New Albany Planning Commission Agenda
Monday, June 3, 2024 at 7:00 p.m.

**Planning Commission Staff Report
June 3, 2024 Meeting**

**PANDA EXPRESS
FINAL DEVELOPMENT PLAN**

project name Panda Express
prepared for City of New Albany
date May 16, 2024
date received April 29, 2024

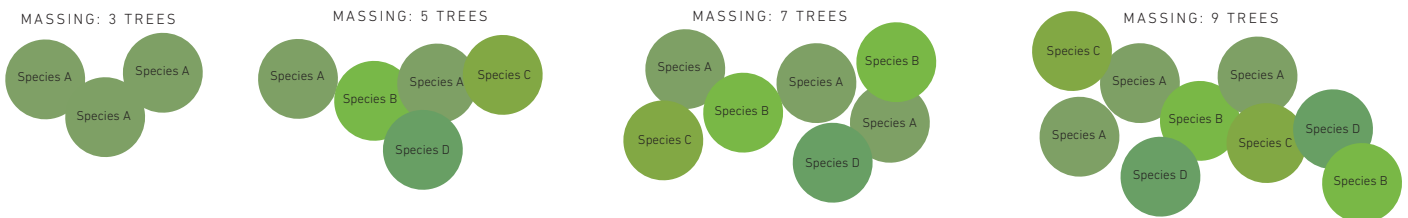
1. Realign the access drive adjacent Johnstown Road to create a consistent transition from the existing drive at the neighboring parcel. See diagram.
2. Realign the proposed parking to follow the building and pavement setback with the shifted access drive, and accommodate minimum parking requirements. See diagram.
3. Reevaluate curb alignment at drive-through entrance. Minimize pavement and striping conditions where possible. See diagram.
4. Consider a safe pedestrian connection into the site from the proposed sidewalk along Woodcrest Way. Recommend considering a future pedestrian connection from the drive at Johnstown Road to connect with the adjacent parcel.
5. Extend the drive-through lane median to reduce pavement and extend landscape planting zone. See diagram.

Proposed Site Plan

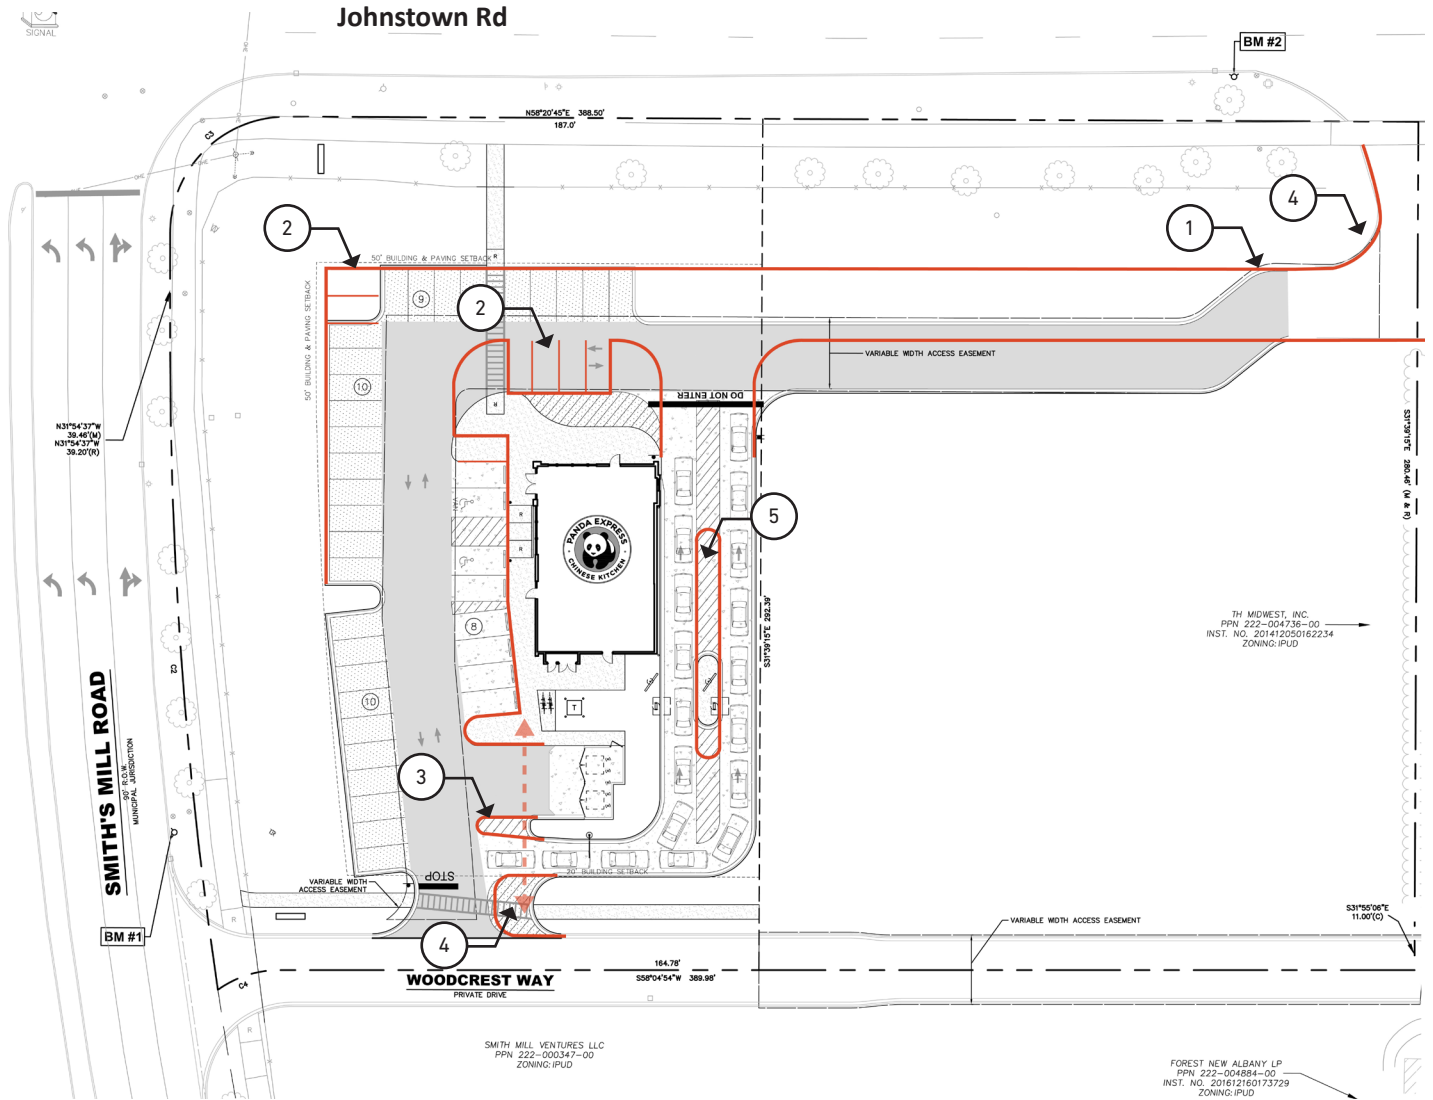
4. The City Landscape Architect evaluated the proposed drive-through and recommends that the applicant extend the drive-through lane median to reduce pavement and extend the landscaping planting zone. Staff recommends this is a conditional of approval.

1. The site is accessed from two proposed curb cuts:
 - a. One full access along Woodcrest Way;
 - b. One existing full access, shared curb cut on Johnstown Road;
 - o The shared drive alignment is skewed. The City Landscape Architect has reviewed the proposed alignment of the shared drive to the north and recommends that the developer realign the access drive adjacent to Johnstown Road to remove the bend/skew to create a consistent transition from the existing drive at the neighboring parcel as depicted below by the “1” circle. Staff recommends this is a condition of approval.

- The City Landscape Architect, in addition to realigning the shared drive, also recommends that the proposed parking be realigned to follow the building and pavement setback with the shifted access drive, and accommodate minimum parking requirements. Staff recommends this is a condition of approval.

Proposed Planting Plan

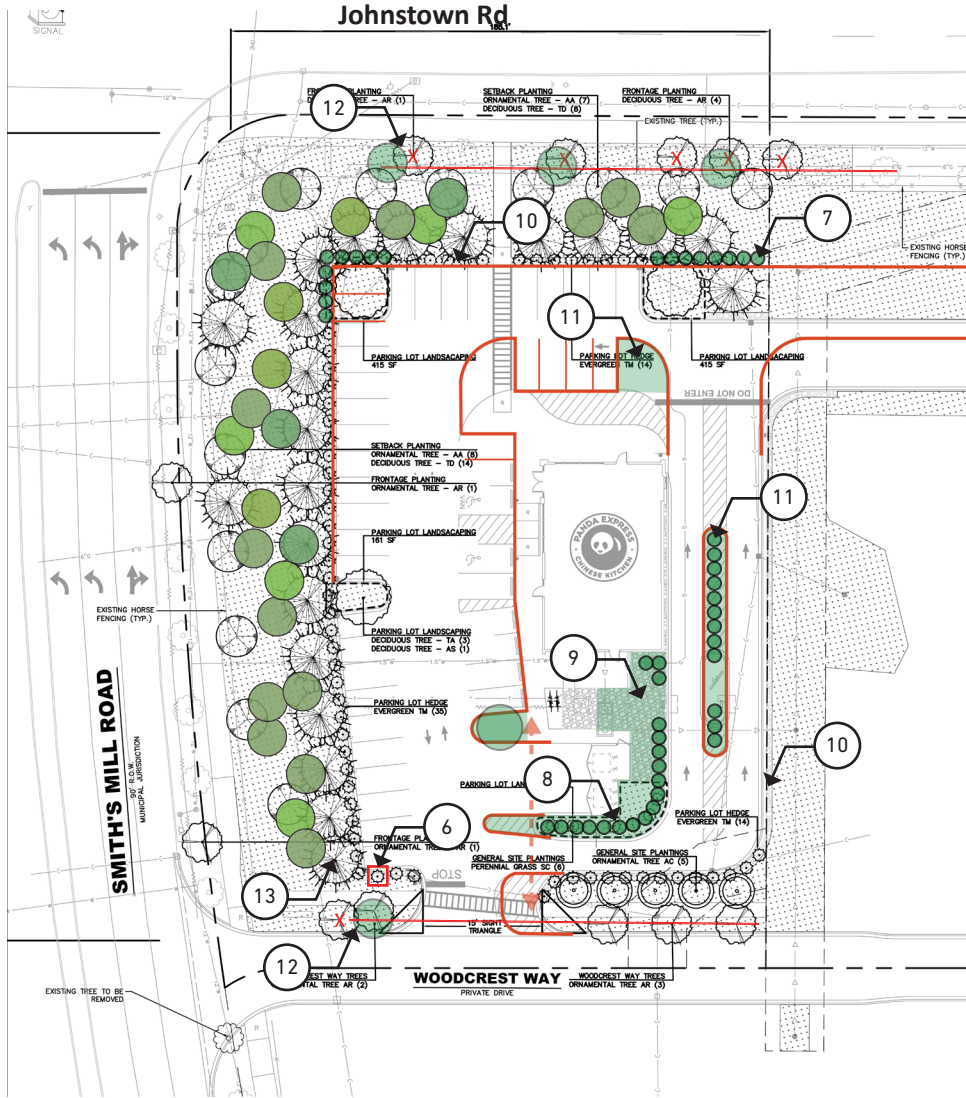
6. Update planting legend and labels to properly reflect proposed plant material. Current plan symbols misrepresent deciduous shrubs along parking lot to be perennial grass. Resubmit updated plant list. See diagram.

7. Extend use of evergreen shrub, 36" in height, to screen end of drive-through. See diagram.
8. Increase density of perennial grass at drive-through entrance. See diagram.

9. Remove the use of rock beds along the drive-through. Extend plant bed and material along the drive-through lanes to match existing conditions present in other sites within New Albany.

10. Remove use of rock beds at edge of pavements. Replace with lawn or mulched planting beds where applicable. See diagram.
11. Include planting in proposed curb extensions. See diagram.

12. Realign trees along Johnstown Road and Woodcrest Way as marked. Placement to be evenly spaced and aligned along both sections. See diagram.
13. Replace use of Bald Cypress (*Taxodium Distichum*) along the parking lot with a deciduous shade tree. Recommend use of one of the following... *Liriodendron tulipifera*, *Nyssa sylvatica*, *Platanus x. acerfolia*, *Gymnocladus dioicus*. Tree placement should adhere to tree grouping standards seen below. Resubmit updated plant list. See diagram.
